Interactive comment on “Meteorological observations collected during the Storms and Precipitation Across the continental Divide Experiment (SPADE), April–June 2019” by Julie M. Thériault et al.

Received and published: 8 January 2021

Fig. 3. Photo of the weather station at Nipika Mountain Resort with the SR50 circled in yellow.

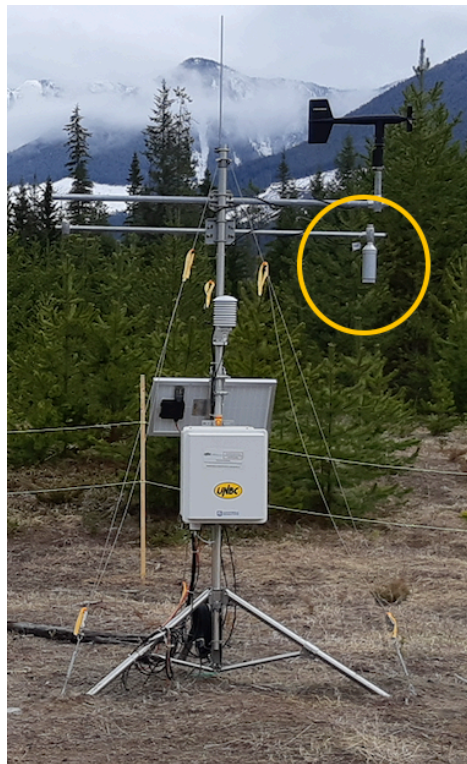
Line 165: Is this just an SR50 or is it an A or AT model? Response: It is (just) a SR50 model and is shown in Figure 3a in the manuscript (Figure 3 in author's response).

Fig. 4. MRR-2 vertical profile of reflectivity (Z_e) from 1700 UTC 4 May–1130 UTC 5 May for (a) NMR and (b) FMP. The grey shading is below ground level.

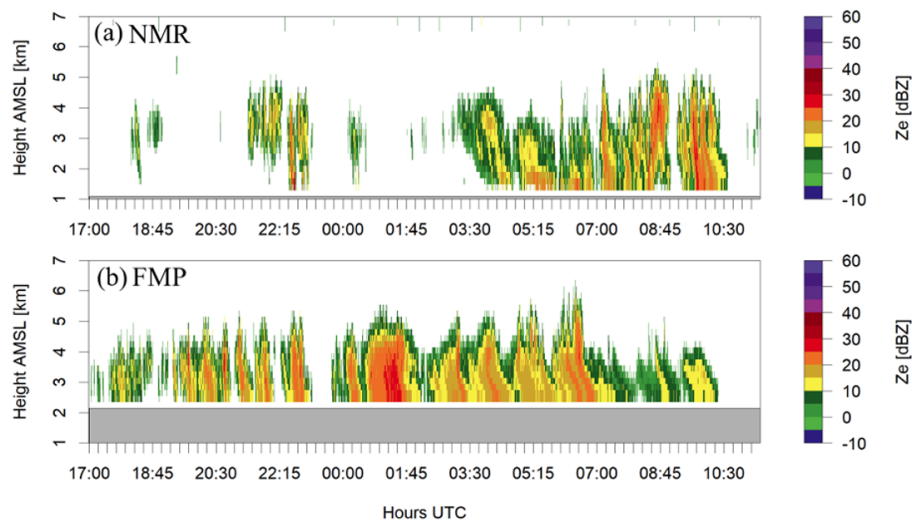
Line 347: It would be useful to label the plots with the site abbreviations. Ditto for Figure 6

Response: The abbreviations were added directly to the plots in Figures 5 and 6 in the manuscript. They are shown in Figures 4 and 5 in the author's response.
